**TECHNICAL EVALUATION REPORT
CHRISTENSEN RANCH MINE UNITS 2 THROUGH 6 RESTORATION REPORT
URANIUM ONE USA, INC., WILLOW CREEK ISR FACILITY**

DATE: October 23, 2012

SITE: Willow Creek Christensen Ranch, Wyoming

SUMMARY AND CONCLUSIONS:

Figure 3c. MU2 North and South Radium-226 Stability Monitoring Trend Analysis

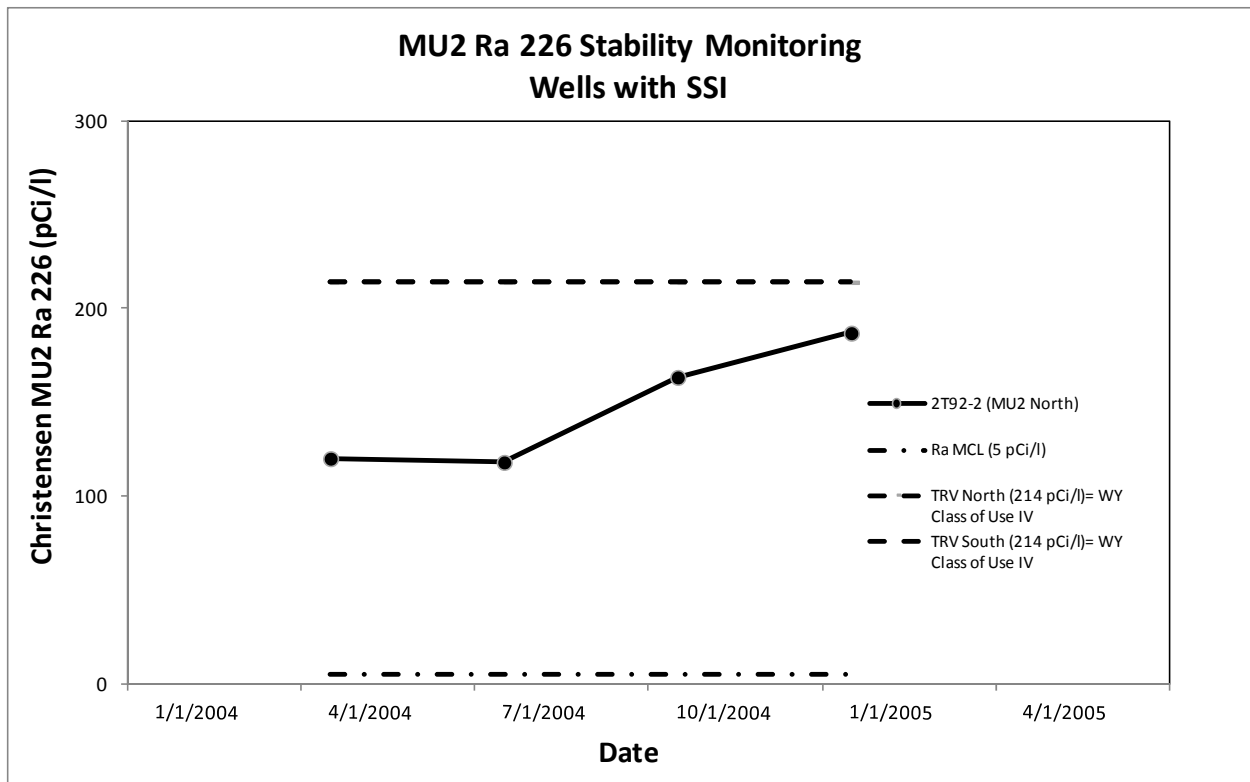
The SSI trend for Mine Unit 2 South for uranium in this well is shown in Figure 3c. It is of concern to the staff because it shows that uranium in this well is above the Class IV standard (background TRV) and is increasing.

- (1) Demonstrate that the SSI trends for uranium and radium-226 at well 2T92-2 are reversed and stable.
- (2) Provide a confirmatory analysis of the groundwater quality at well 2MW108 subsequent to the corrective actions for the 2011 excursion that demonstrates impacts to the aquifer following the 2011 excursion event meet regulatory requirements (groundwater protection criteria).
